Volume II
of the
Final EIS/EIR for the
Van Ness Avenue BRT Project

Appendices I & J

Response to Comments

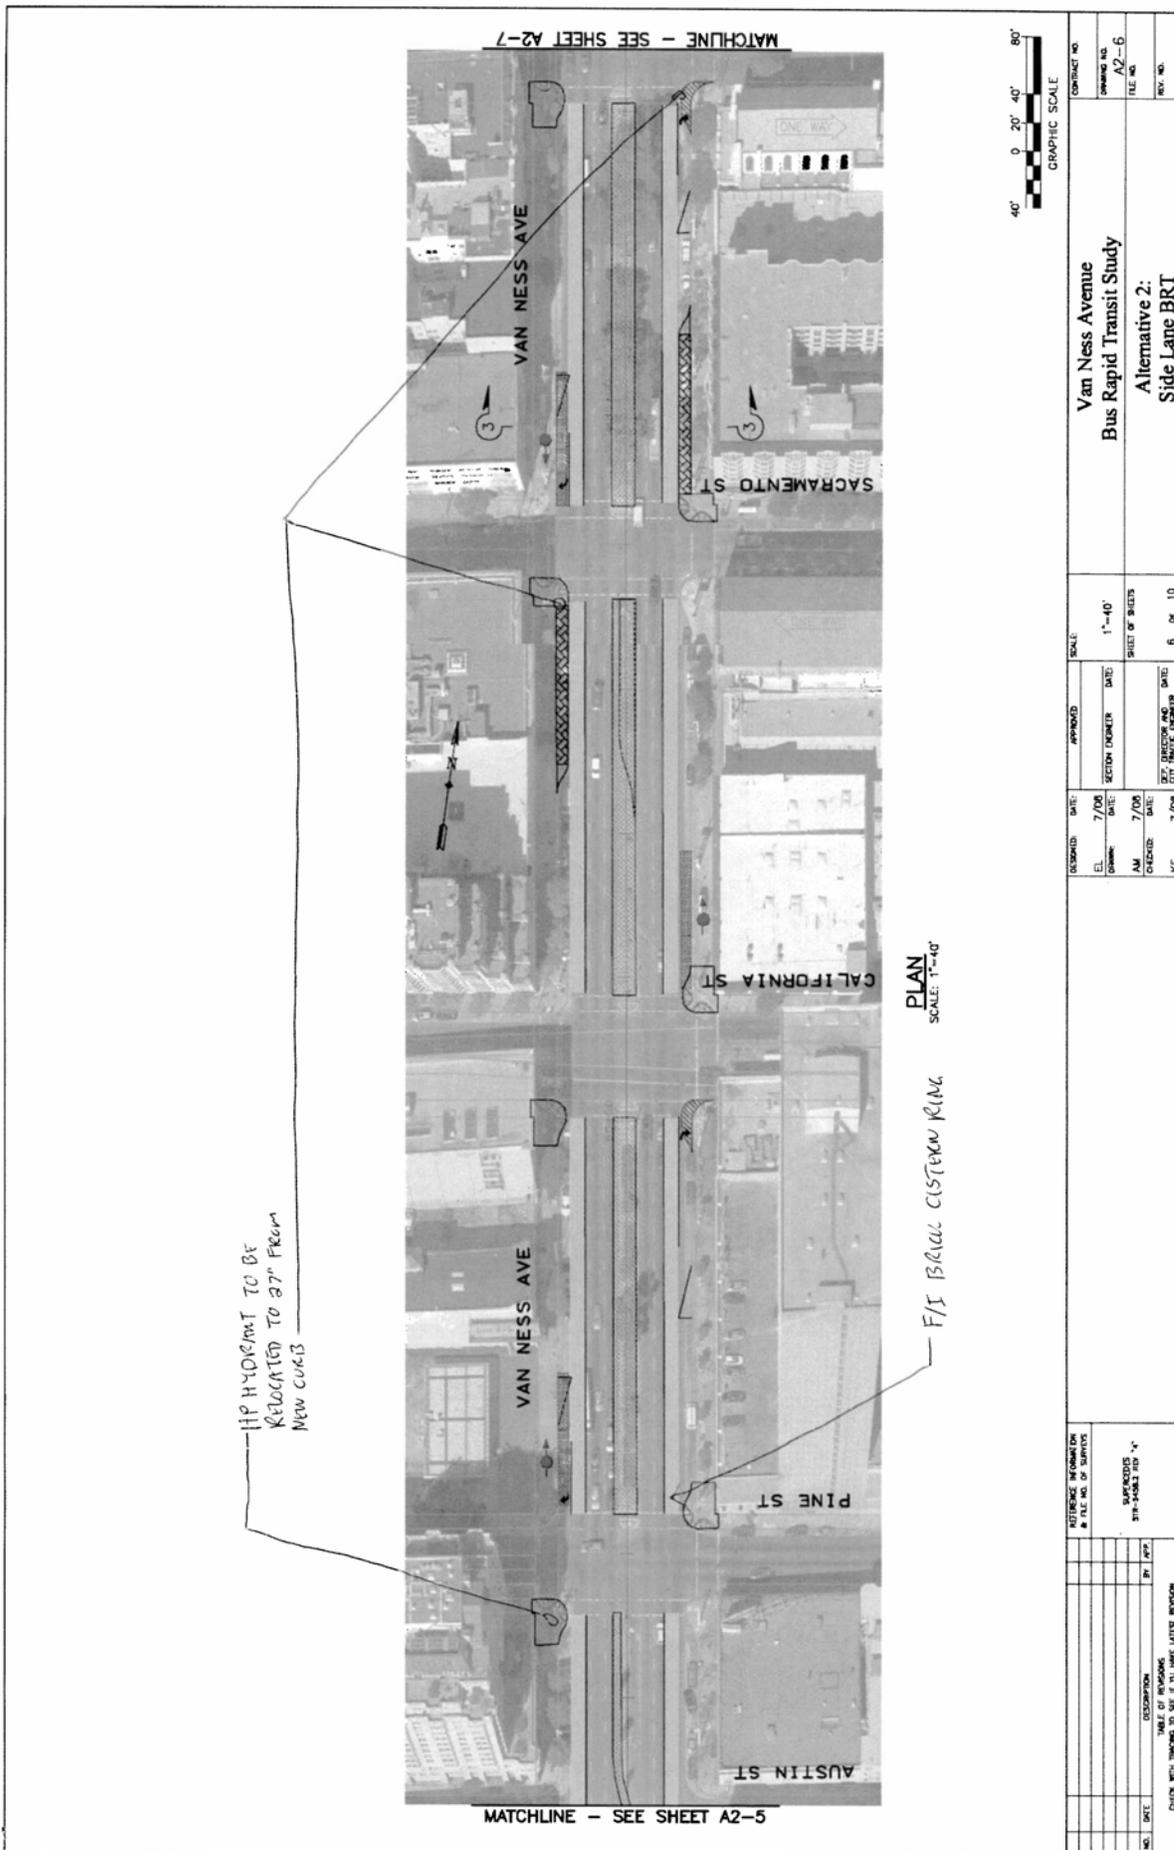
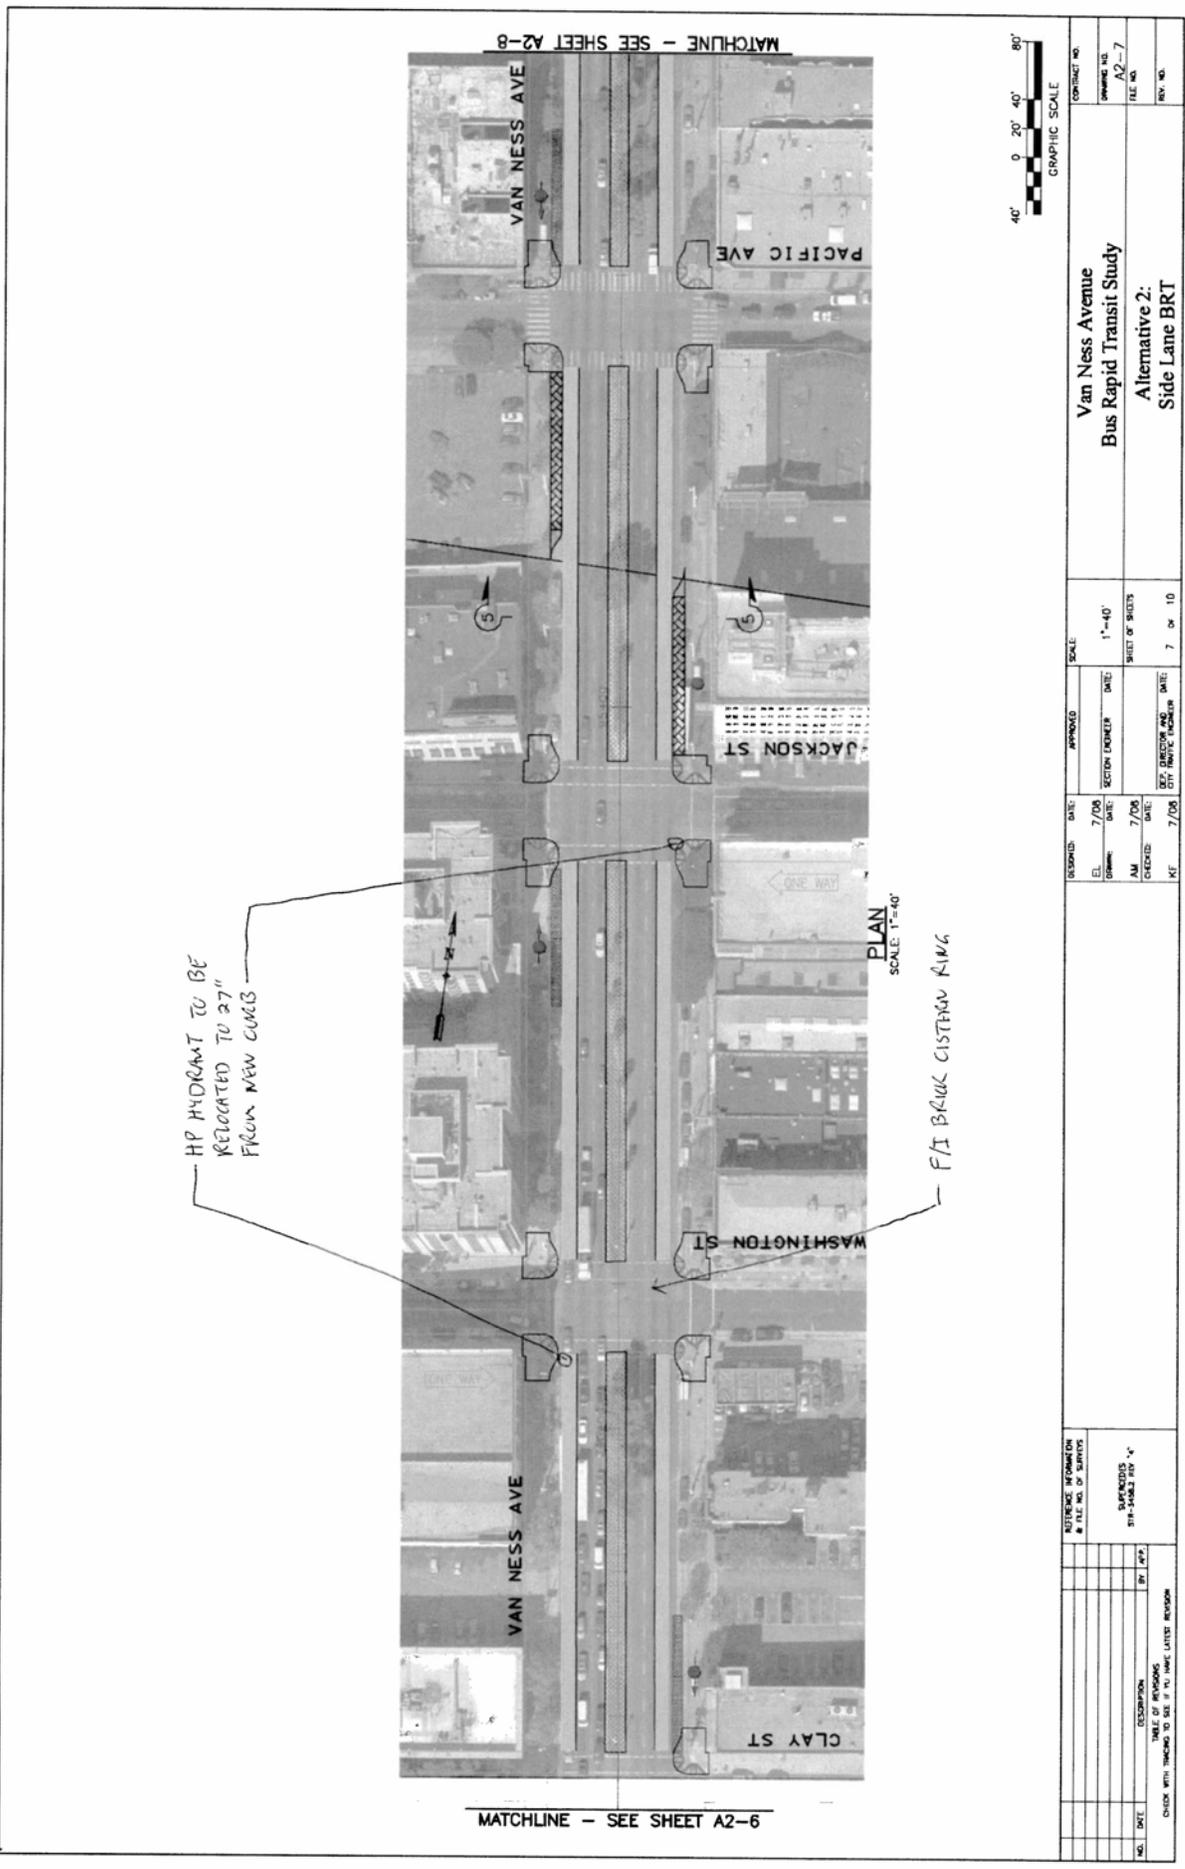
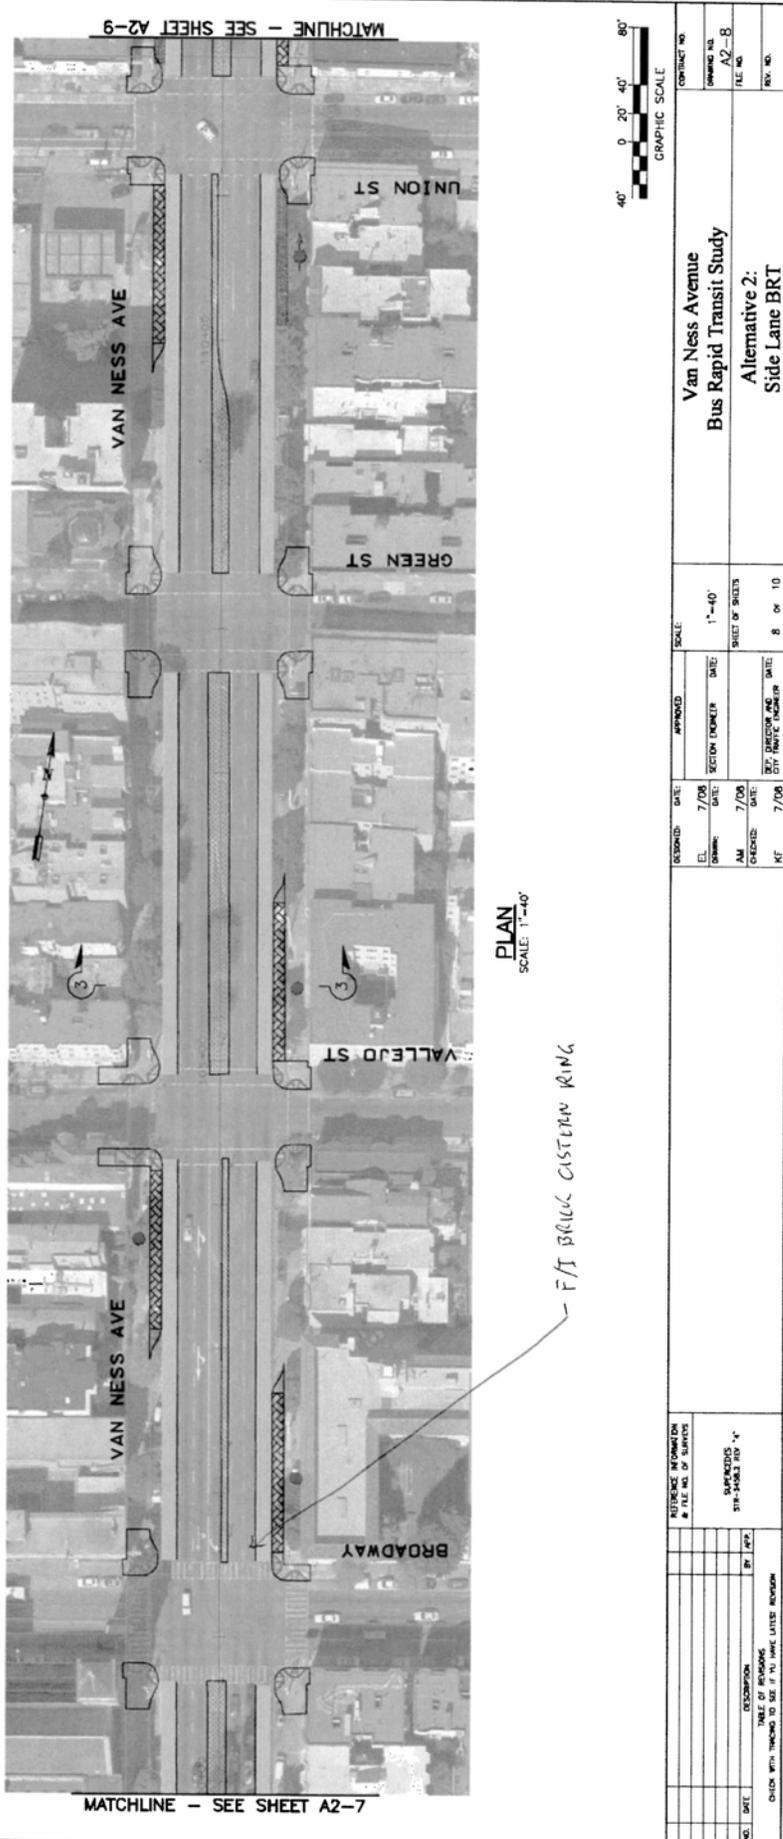
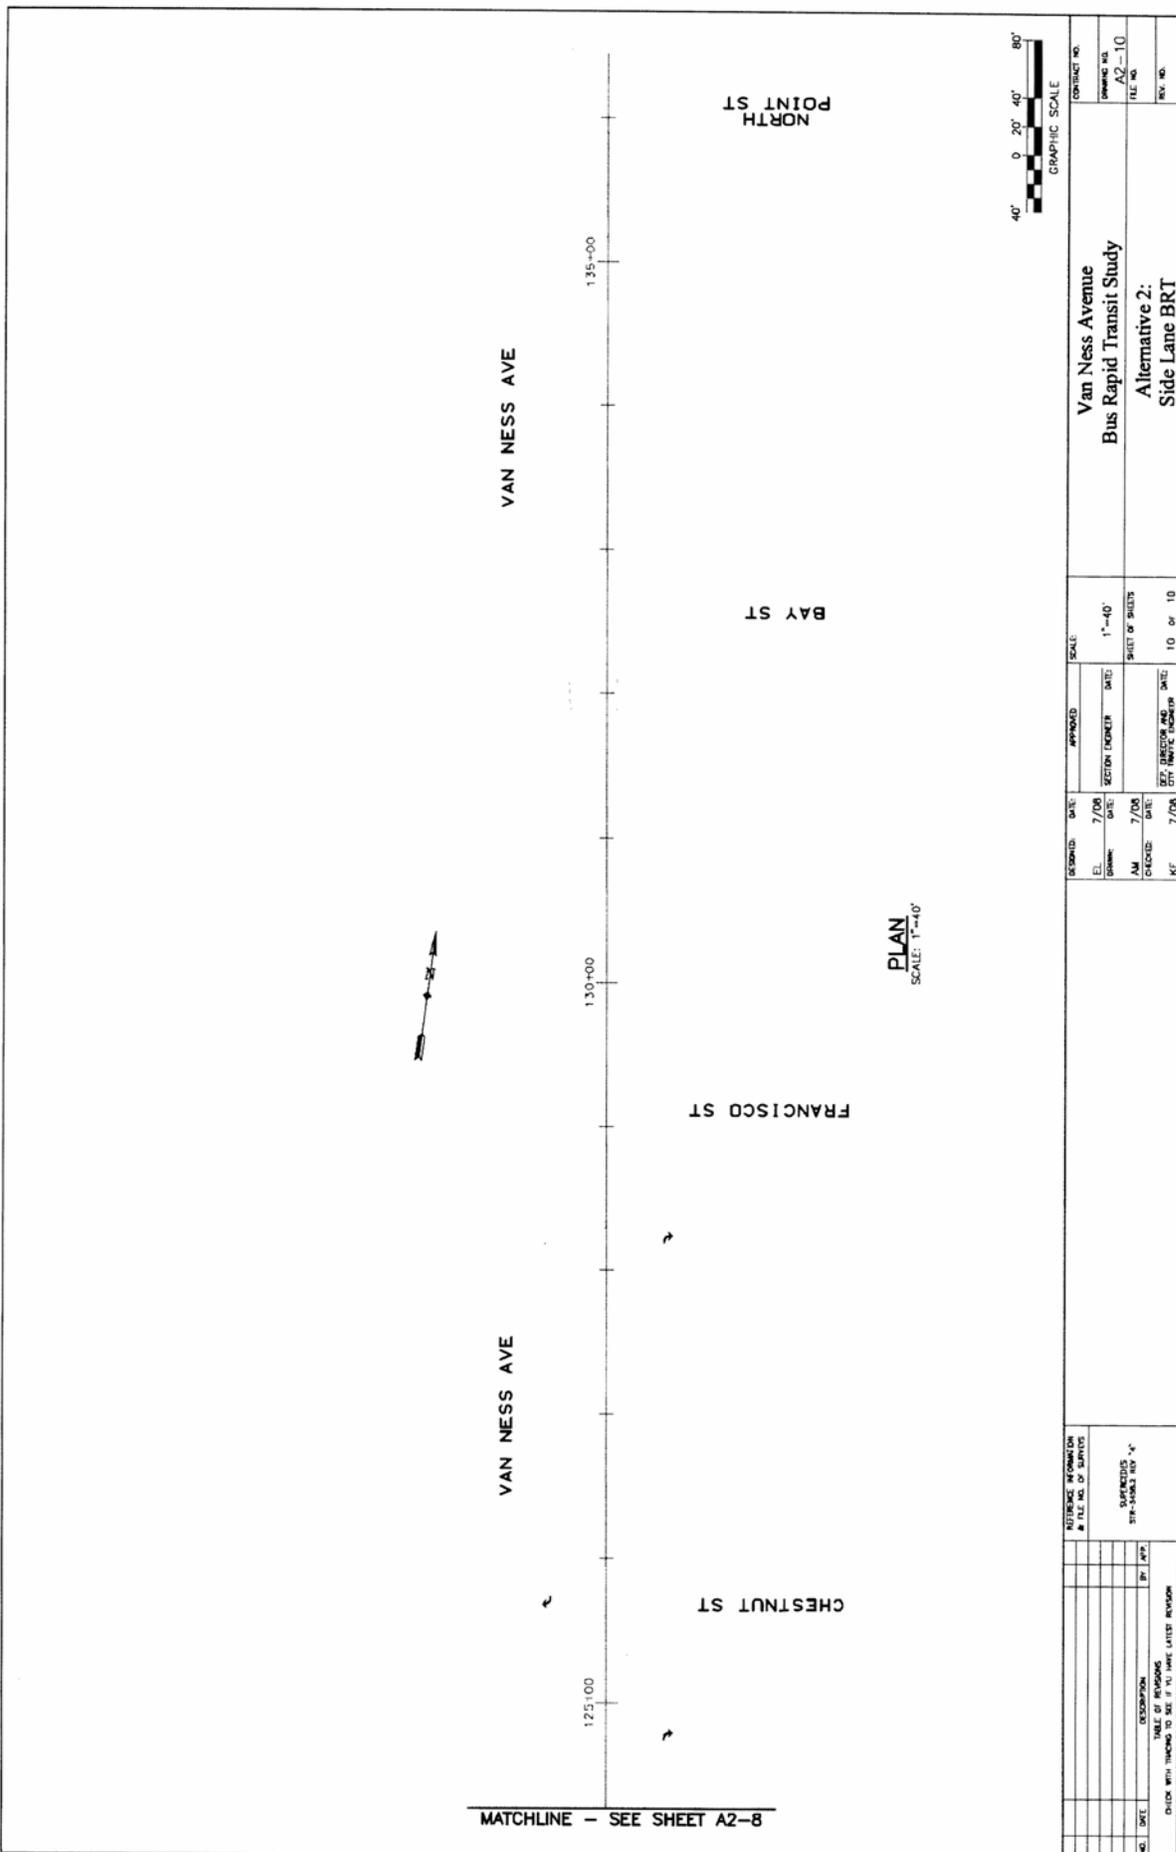
A-7e-60 continued

A-7e-60
continued

HP HYDRANT TO BE
RELOCATED TO 37" FROM
NEW CURBS
